Submission ID	Name	I / We	Name of organisation (if applicable)	Comments	Project team response
11008	Nigel Weston	have some concerns		<p>Regulatory speed limit changes are usually done in 20 km/hr increments. The change from 50 to 40 is negligible and will not, in my opinion, change the average speed in these streets significantly.</p> <p>No reference has been made to the results from applying this speed limit in Charleston where 40 km/h has been in place for many years?</p> <p>I suggest the limit be 30 km/h as has been done in the CBD and is common in many European cities.</p> <p>A significant lowering of the risk to pedestrians of serious injury is gained by the lower speeds around 30km/h even from 40 km/h.</p>	<p>Thank you for your submission.</p> <p>The majority of the proposed area has recorded average speeds around or below 40km/h. Changing the posted speed limit from 50km/h to 40km/h is aligned with actual speeds and gives the proposed posted speed limit credibility in accordance with NZTA speed management guidelines and a recent revision to the Land Transport Road user Rule: Setting of Speed Limits 2017.</p> <p>Some streets within the proposed area have no traffic calming an

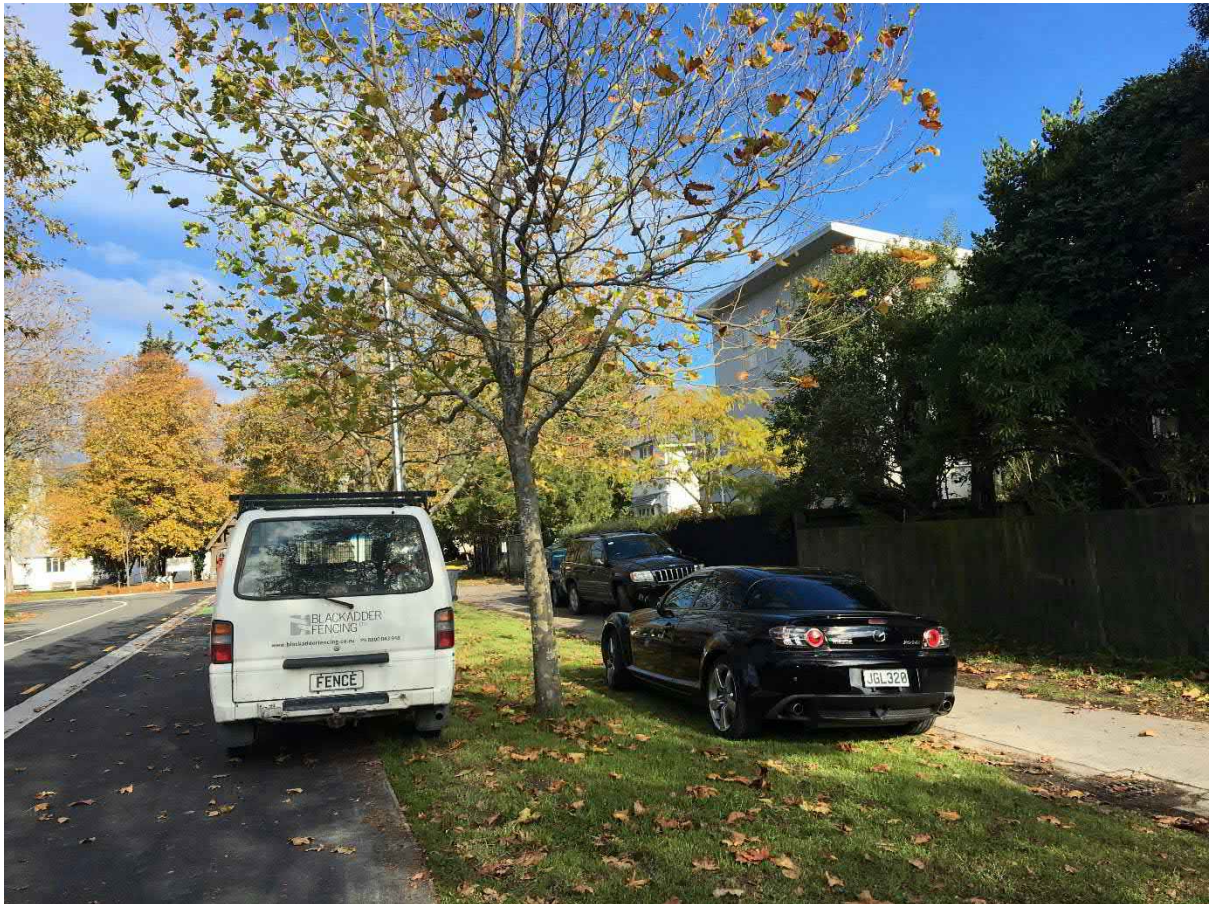
I am attaching a couple of photos to show the sort of things happening in Grove Road which could not be uploaded to the online survey send out recently.

I have more should they be necessary. The most important aspect of this whole issue is that 40 kp/h could be too fast. The street cannot cope with parking on the East Side of the street. People are stopping to let others through regularly and many have complained about the street since the recent changes have been made. It is decidedly dangerous, and if the parking was disallowed then it might work in a better way but still caution is necessary. At the end of the day 4-5 pm people are using Grove Road as a detour from Selwyn Street which does get very congested some days.

Also it is now necessary to check for bikes – both ways and traffic both ways. Some bikes do not even use the bike lane.

Submission ID	Name	I / We	Name of organisation (if applicable)	Comments	Project team response
10107	Helen Arnold			<p>I am attaching a couple of photos to show the sort of things happening in Grove Road which could not be uploaded to the online survey send out recently.</p> <p>I have more should they be necessary. The most important aspect of this whole issue is that 40 kp/h could be too fast. The street cannot cope with parking on the East Side of the street. People are stopping to let others through regularly and many have complained about the street since the recent changes have been made. It is decidedly dangerous, and if the parking was disallowed then it might work in a better way but still caution is necessary. At the end of the day 4-5 pm people are using Grove Road as a detour from Selwyn Street which does get very congested some days.</p> <p>Also it is now necessary to check for bikes both ways and traffic both ways. Some bikes do not even use the bike lane.</p> <p>I am sending in the other form as well but I cannot upload the photos. I have more.</p> <p>Many thanks Helen</p>	<p>Thank you for your submission.</p> <p>30km/h is more suited for roads with high volumes of pedestrians and cyclists such as town and city centres.</p> <p>The proposal is in a residential area with relatively high pedestrian and cycle numbers, but not high enough to justify a 30km/h posted speed limit.</p> <p>The parking issue on Grove Road has been raised as a customer service request CSR92364049 for the area traffic engineer to investigate.</p>

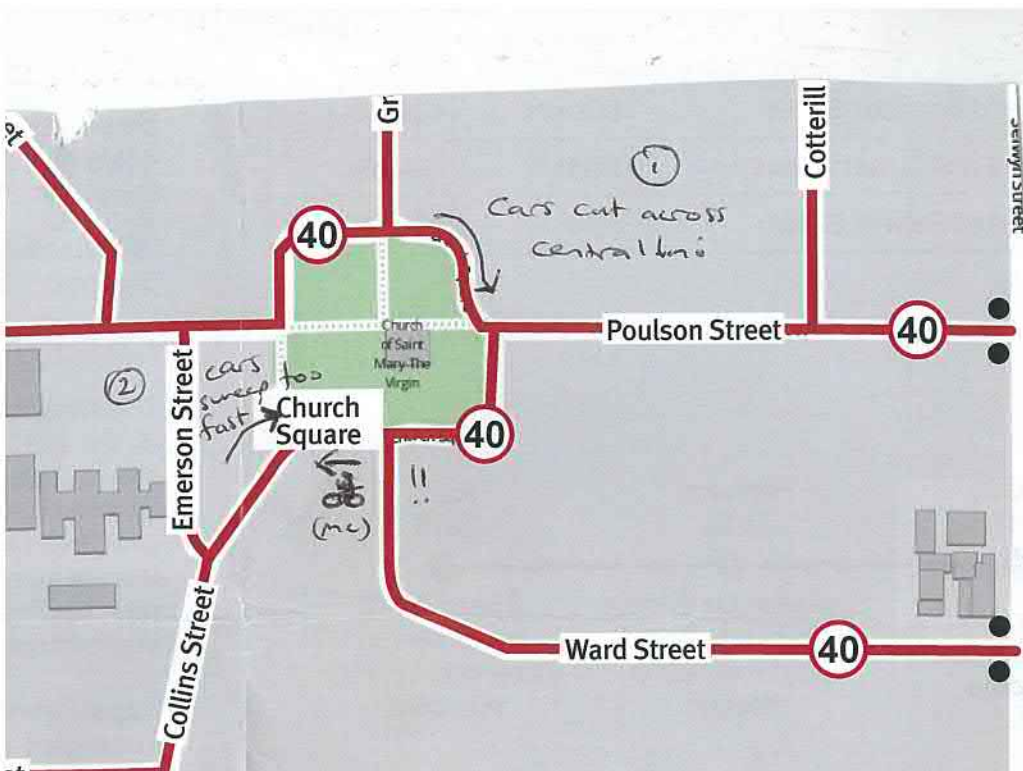
As a cyclist I support any measure  
 that assists motorists' awareness of  
 keeping speeds down around blind corners  
 and church square  
 For me there are the concerning sections  
 (see enclosed document)  
 Thank you  
 Honora Fenwick

*cars sweep too fast*

*Cars cut across central bus*
